PROPOSED MIXED-USE DEVELOPMENT, WHALLEY TRANSPORT ASSESSMENT ADDENDUM NOTE REV A

VN91274 – TA Addendum Note Rev A

4. Comments (dated 7th January 2020) on the TA were provided by Lancashire County Council (LCC) Highways Development Control Officer, Neil Stevens, and these are provided at **Appendix A** to this Note. Subsequently, Vectos met with Neil Stevens on the 19th February 2020 at the RVBC offices in Clitheroe to discuss the comments, and further dialogue has taken place over the course of 2020, with further information provided to LCC Highways through a TA Addendum Note in July, to which comments were provided by LCC Highways in October 2020. This revised TA Addendum Note therefore responds to all the comments received from LCC Highways to date.

DRAWING NUMBER:	VN40390-SK001	REVISION:	F
-----------------	----------------------	-----------	----------

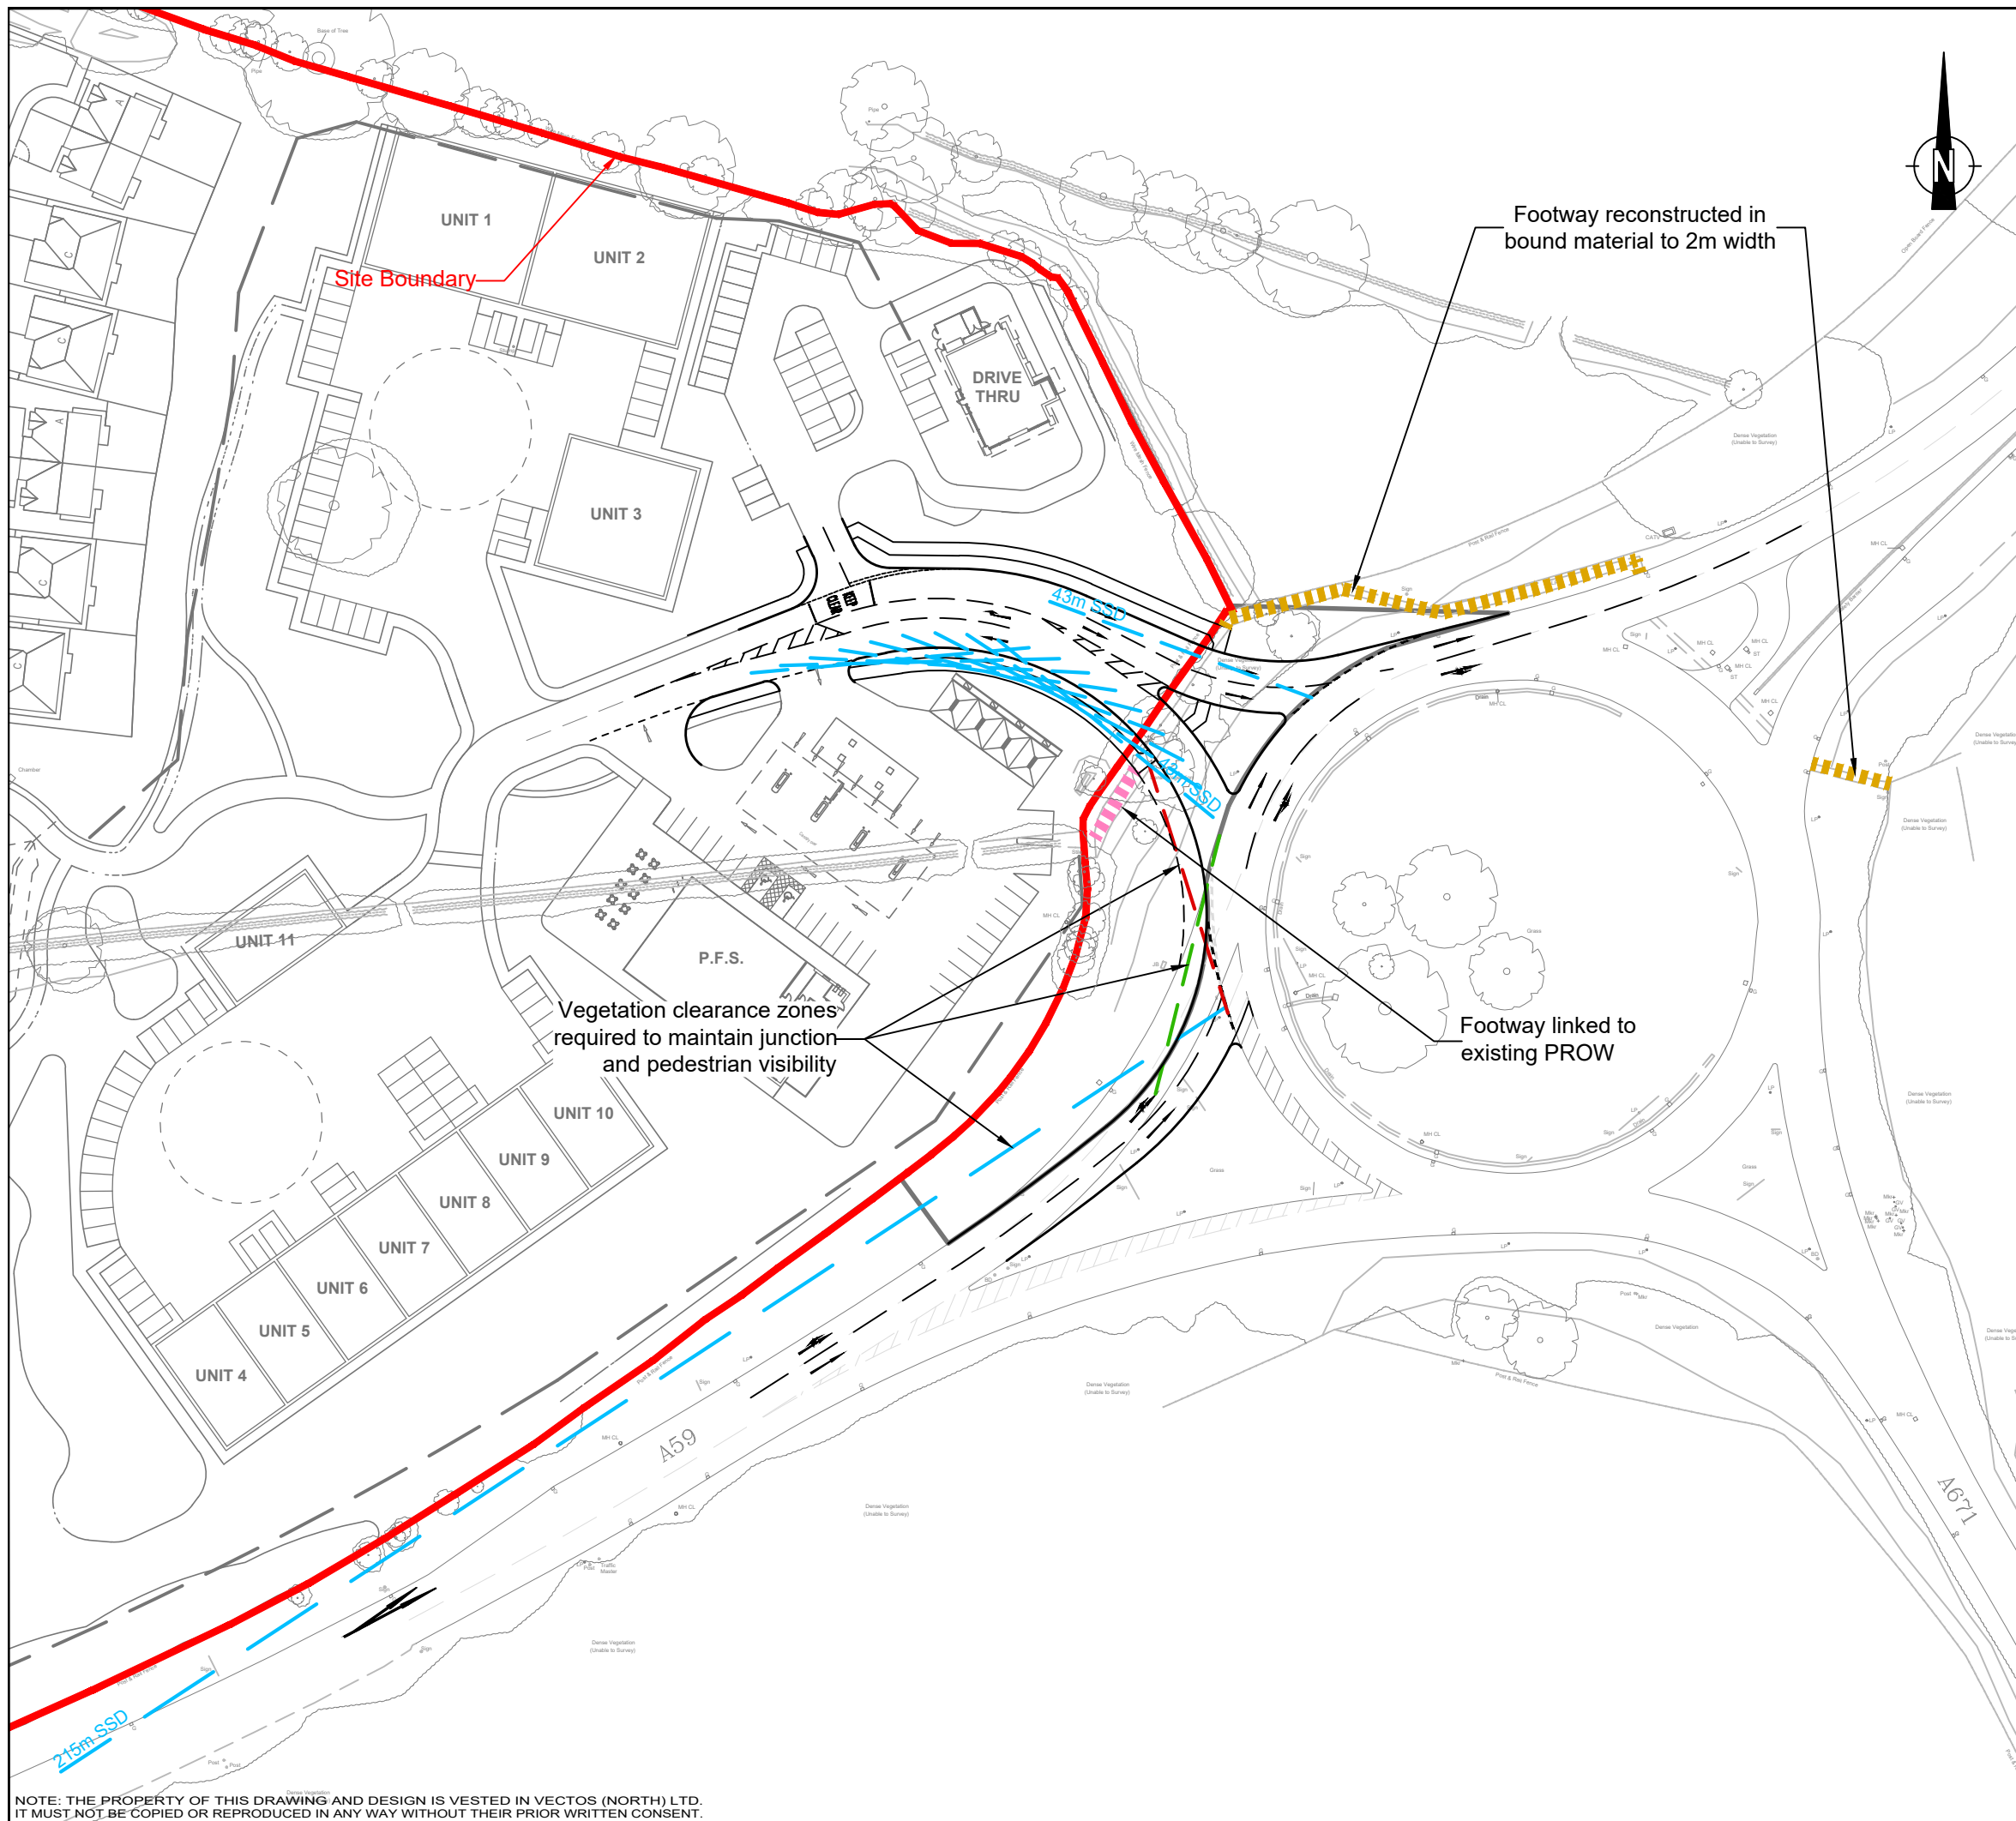
Problem – Uphill gradient may result in HGVs entering the roundabout at reduced speeds

Issue: During the site visit it was observed that the proposed development site appeared to be at a lower level than the existing roundabout. This may result in an uphill gradient on the new access road approach to the roundabout. An uphill gradient may result in HGVs entering the roundabout at reduced speeds, which may increase the risk of collisions with vehicles circulating the roundabout at higher speeds.

Recommendation: The design of the new access road should allow for a length of level gradient at the roundabout to ensure HGVs are not entering the roundabout from an uphill gradient.
